# RIDGE PORT NORTH 2ND ADDITION

## WICHITA, SEDGWICK COUNTY, KANSAS

RE: S/D 99-59 — One-Step Final Plat of RIDGE PORT NORTH SECOND ADDITION

RE: S/D 99-59 — One-Step Final Plat of RIDGE PORT NORTH SECOND ADDITION

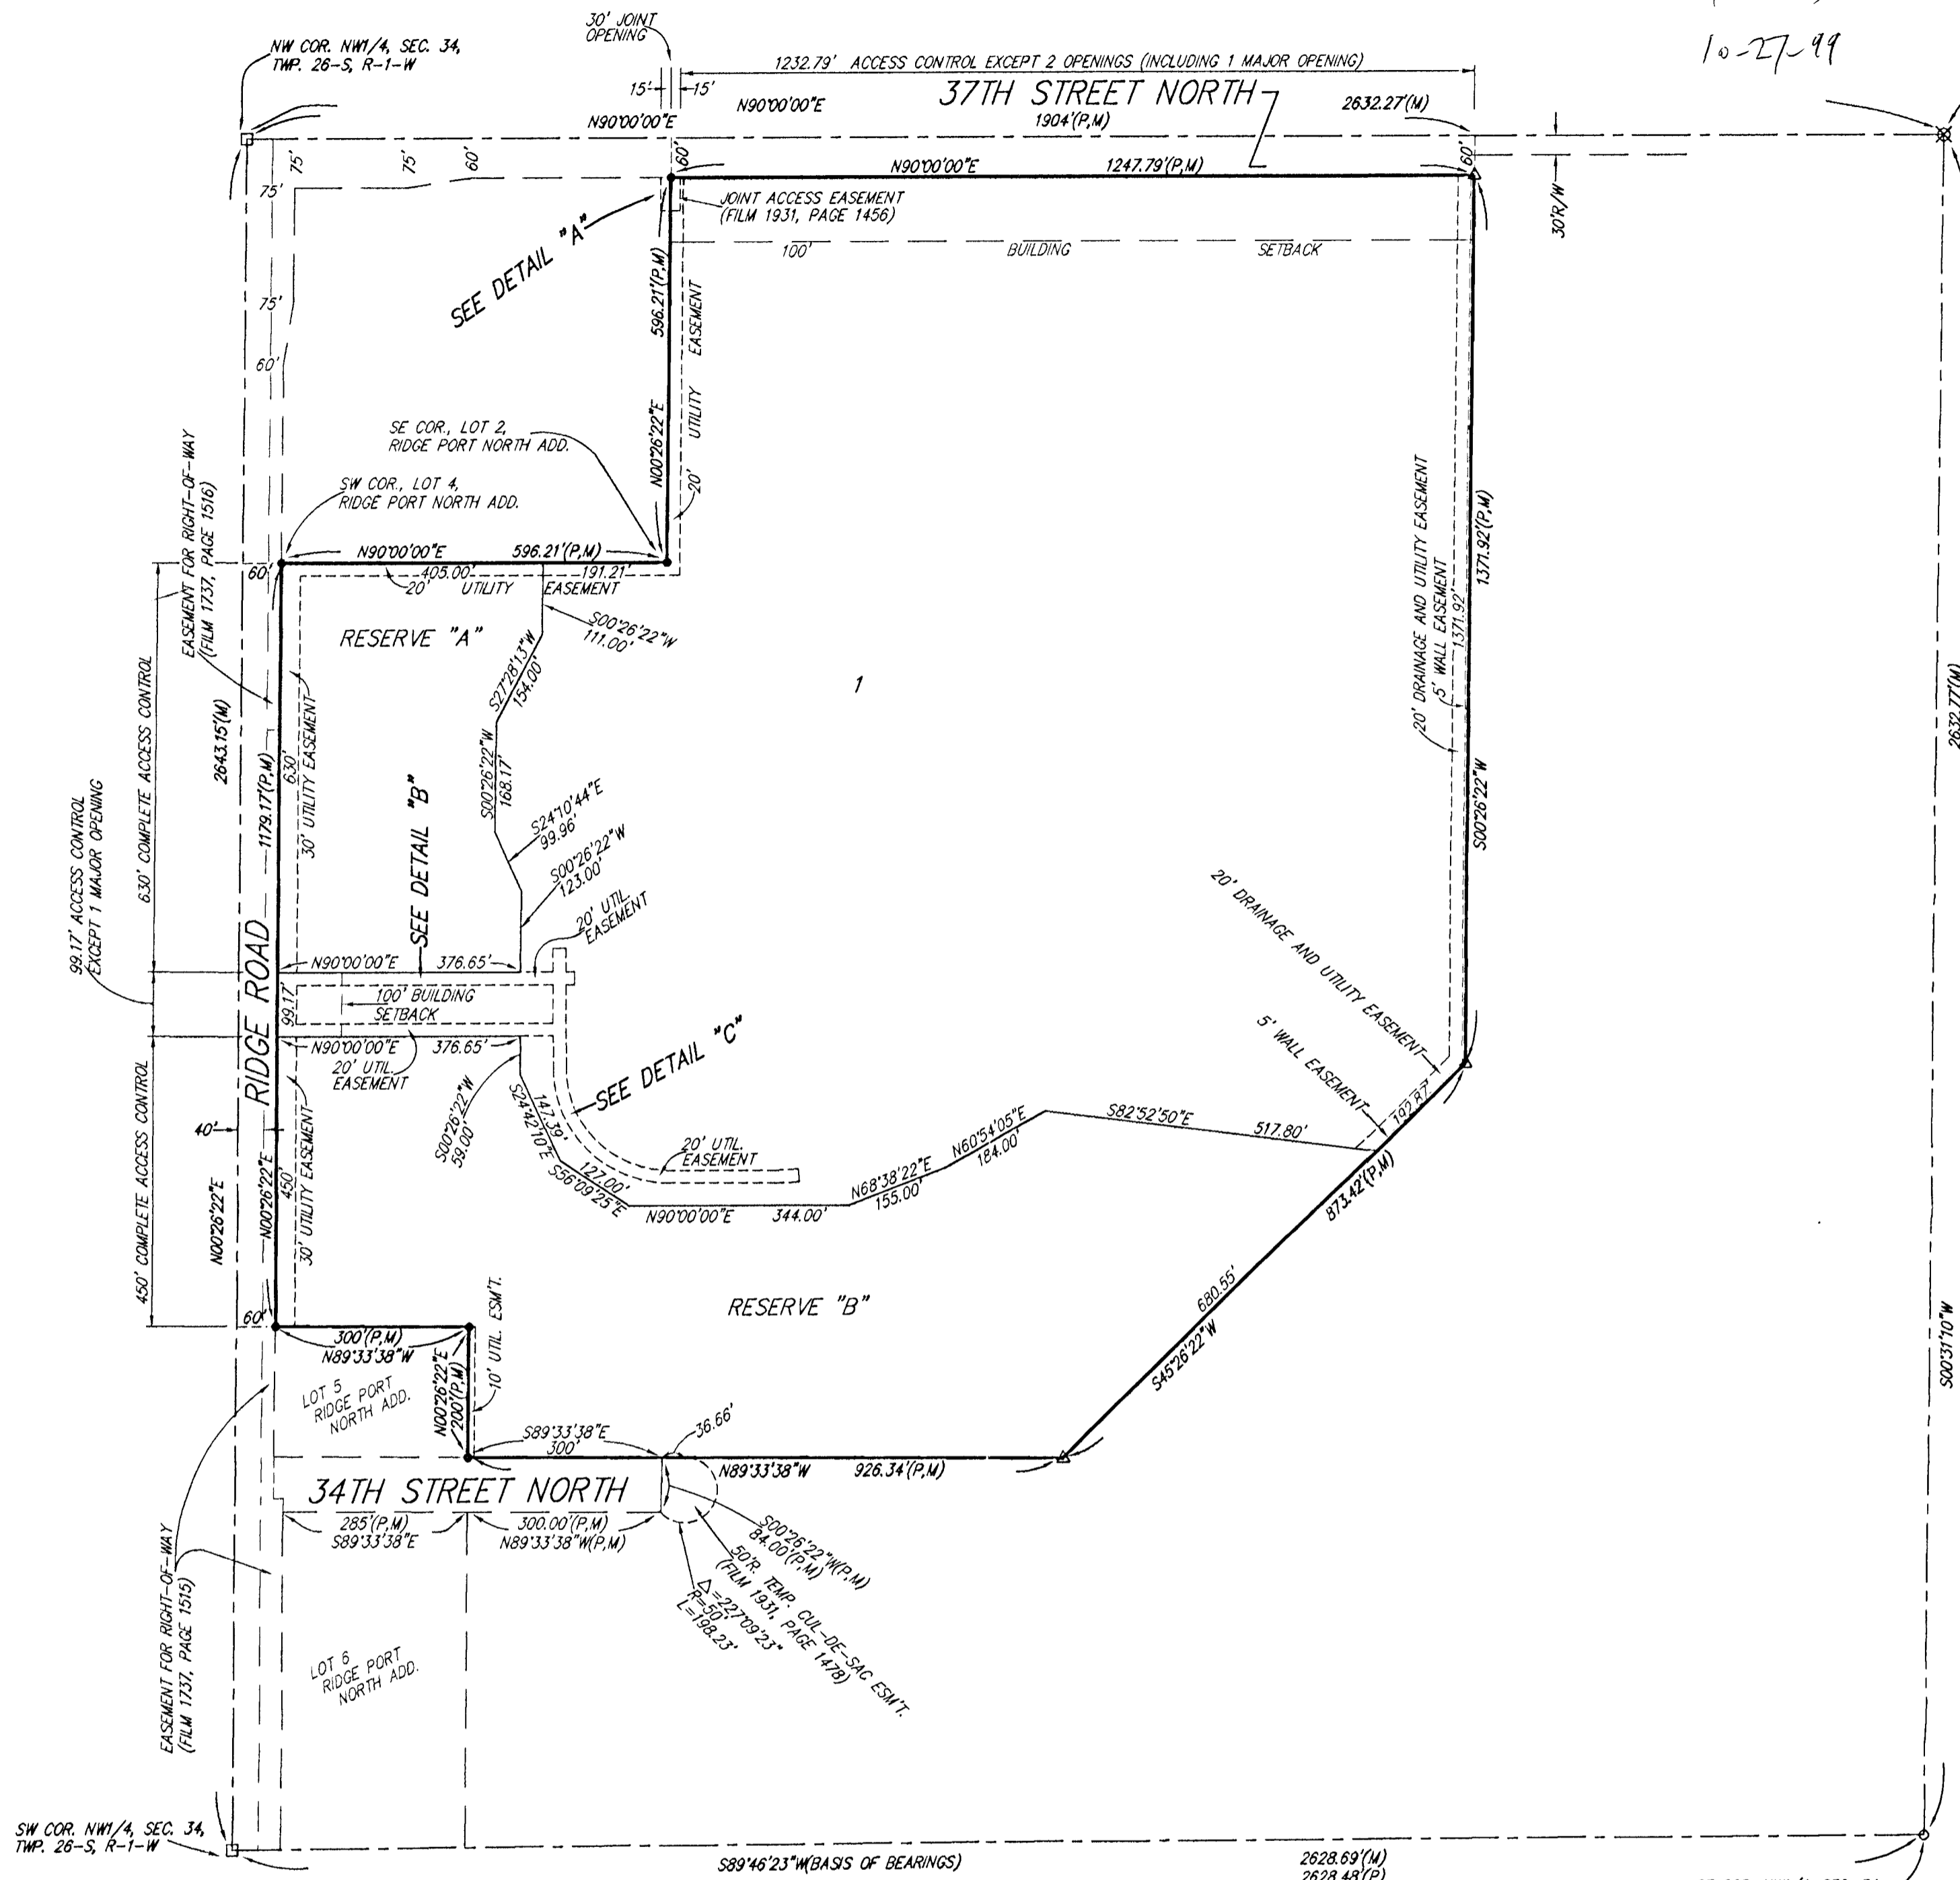
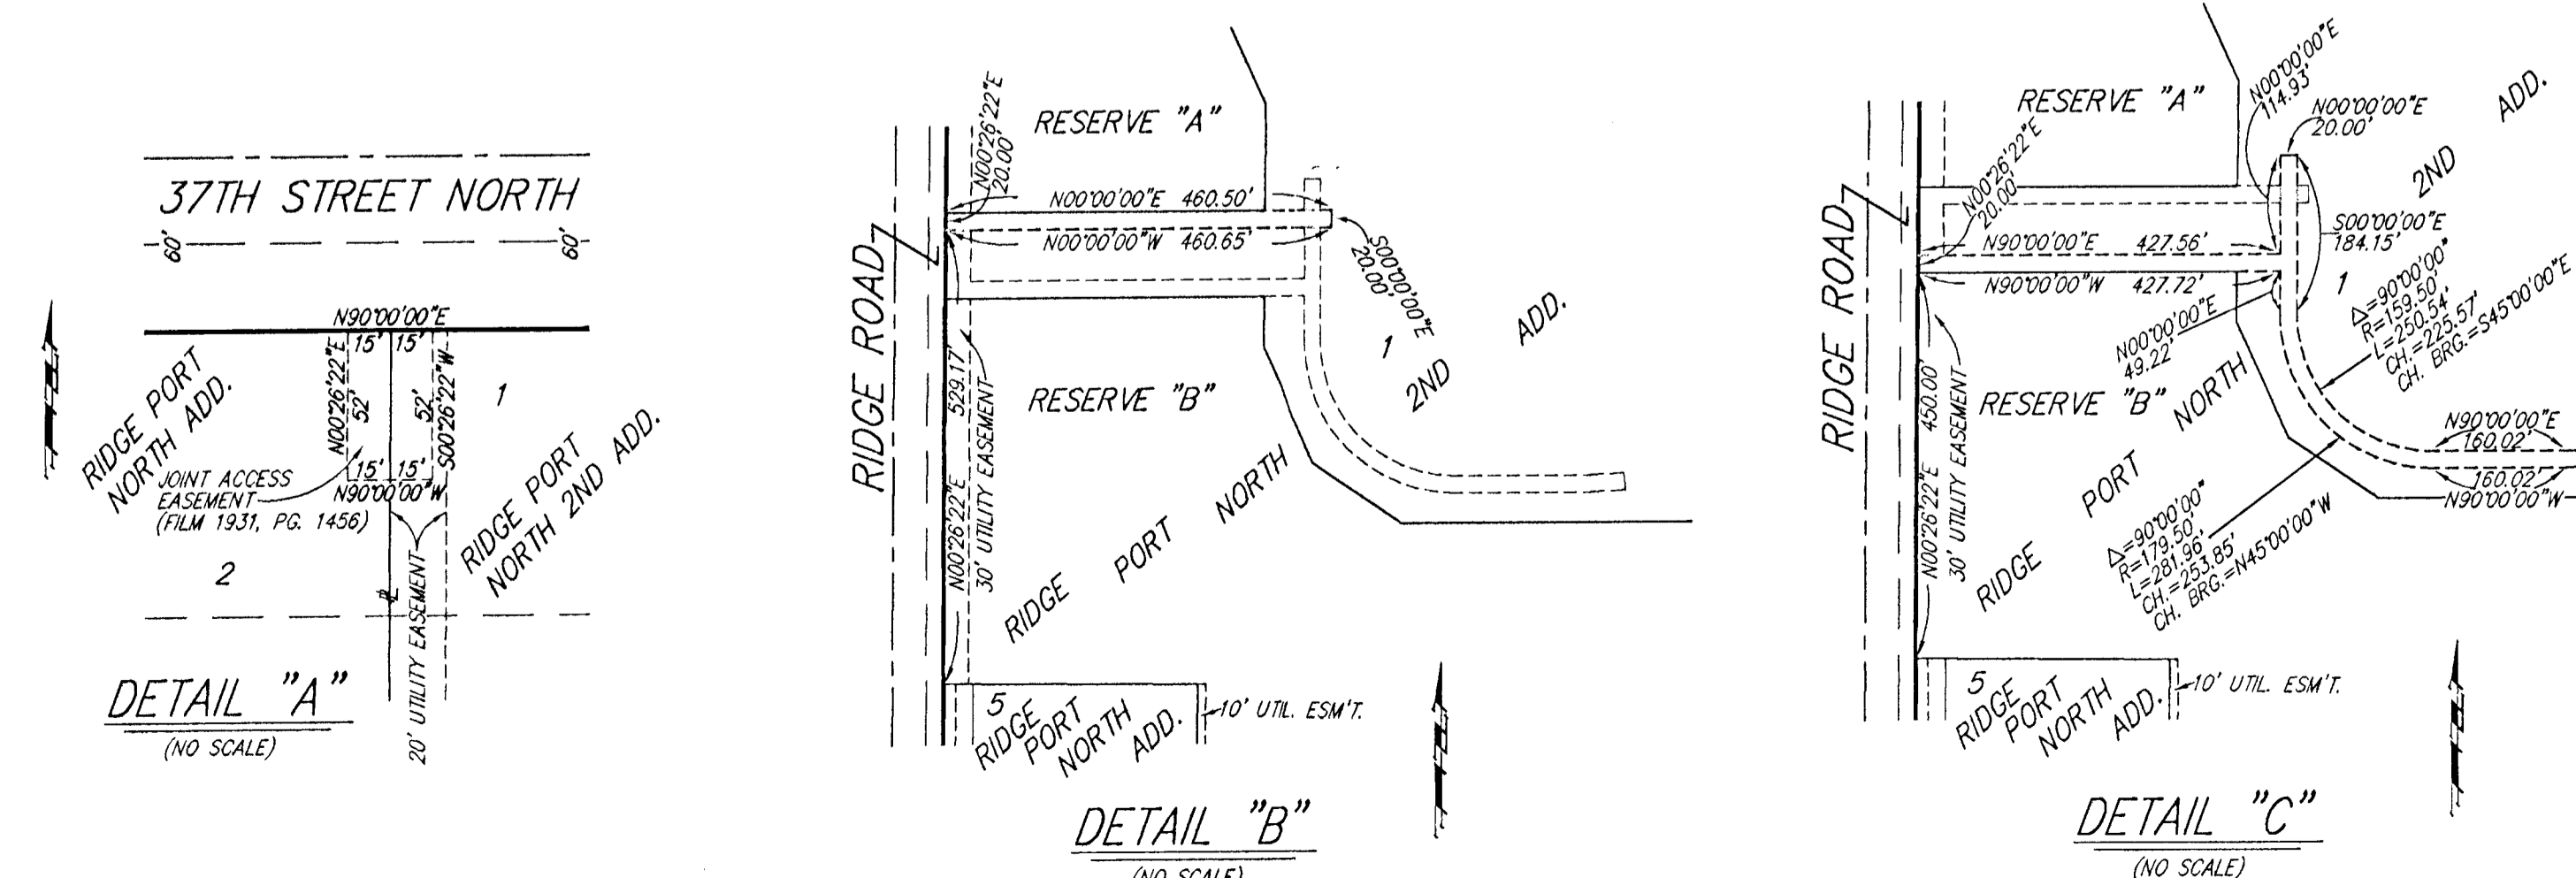
- D. City Engineering needs to comment on the status of the applicant's drainage plan and the accuracy of the minimum building pad elevation. The minimum building elevation shall also be denoted in NGVD. City Engineering needs to comment on the need for a revised petition for the drainage improvements. *The drainage plan is approved.*

- G. Traffic Engineering shall comment on the access openings. The access openings correspond with those approved for the CUP and Ridgeport North Addition. Two openings have been platted along 37<sup>th</sup> St. North – one joint opening with the property to the west, and one major opening. The platted access controls indicate two openings along Ridge Road, although the drawing only denotes one proposed opening. The plat shall be revised to denote access control except for one major opening along Ridge Road and a corresponding CUP adjustment shall be filed.

- L. The surveyor's certification shall be revised by referencing "a replat of Lot 1, Ridge Port North Addition".
- M. The recording information shall be denoted for the existing joint access opening between this plat and the lot to the west along 37<sup>th</sup> Street North.
